MEMPHIS AND SHELBY COUNTY OFFICE OF PLANNING AND DEVELOPMENT

STAFF REPORT

CASE NUMBER: P. D. 09-302 CC **L.U.C.B. MEETING:** July 9, 2009
Held from May 14, 2009

DEVELOPMENT: CORDOVA RIDGE PLANNED DEVELOPMENT, 4TH Amendment

OUTLINE/CONCEPT PLAN:

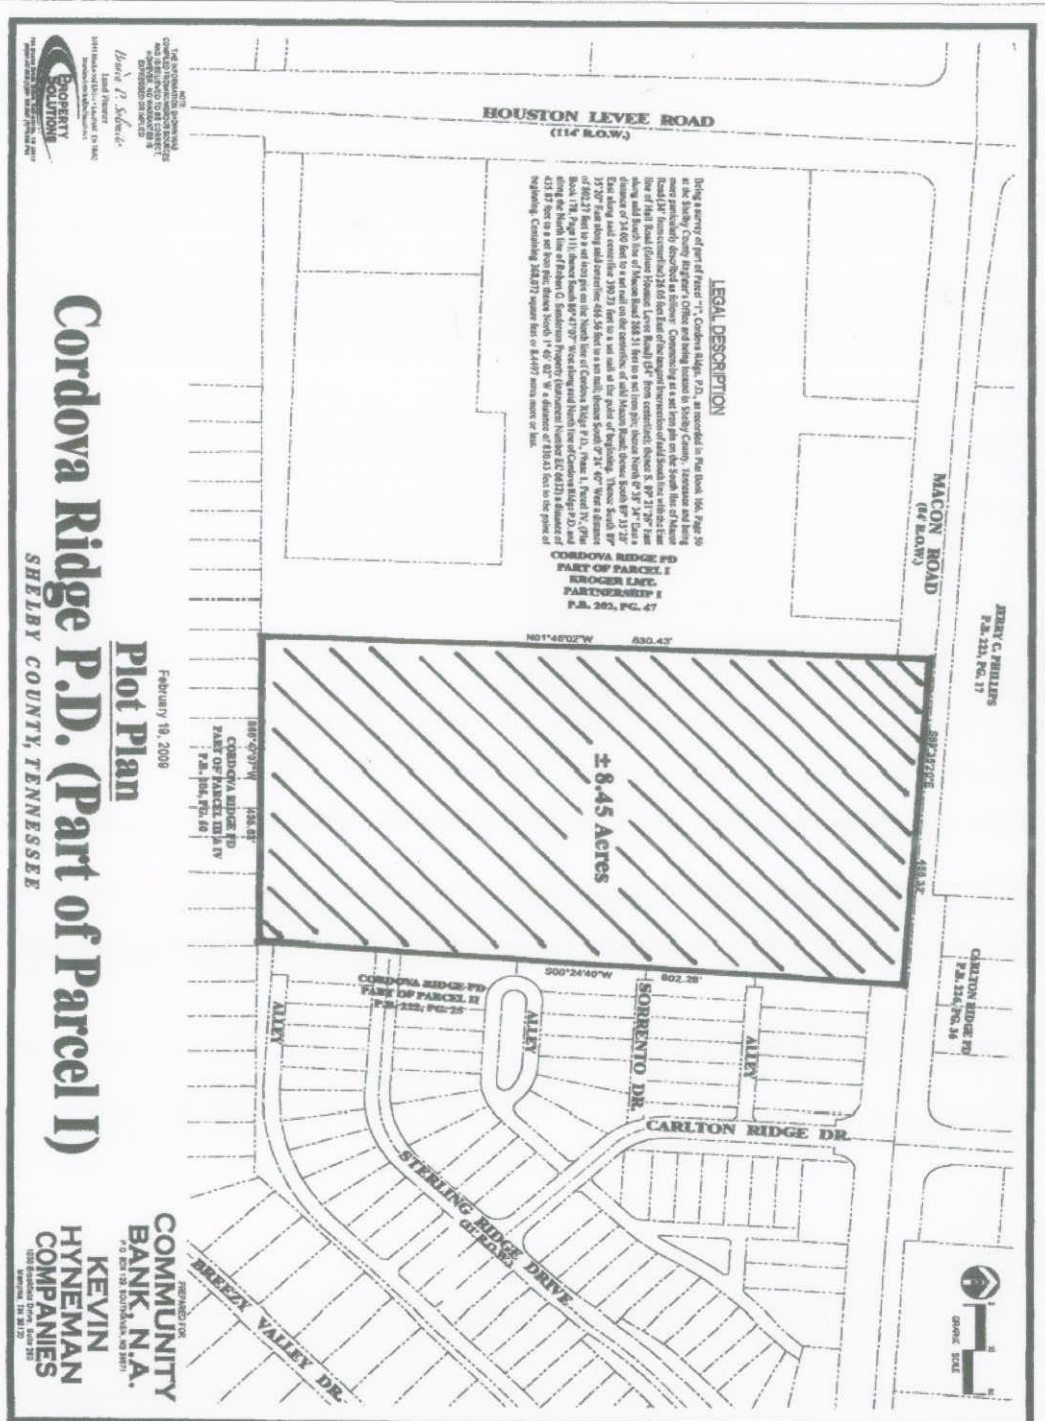
1. The requested amendment to Parcel 1 of the Outline Plan is to allow self-service mini-storage warehouses to be located to the rear of a large retail building in the center of the parcel, including a bank and a small retail building along Macon Road as depicted on the Concept Plan.

2. This amendment proposes to create Parcel 1-B to also allow outdoor storage for recreation vehicles located to the interior of the storage buildings. The original plan approved in 1996 allowed office development in Parcel 2 as a transitional buffer zone between commercial at the major road intersection and single family residential development.

4. Furthermore, Sterling Ridge Drive should be considered as an extension to 'Cordova Ridge Shops' to maintain interconnectivity within this development. The total block perimeter measured from the intersection of Breezy Valley Drive and Macon Road is 6,000 feet which far exceeds the recommended maximum block length of 3,000 feet.

5. The single family residential development within this plan is within walking distance of a neighborhood center. This development plan should be more compatible with residential development and provide pedestrian walkways and street connections. This amendment to allow a modification to a land use plan should incorporate recommendations of staff and the Gray's Creek Association in the Concept Plan.
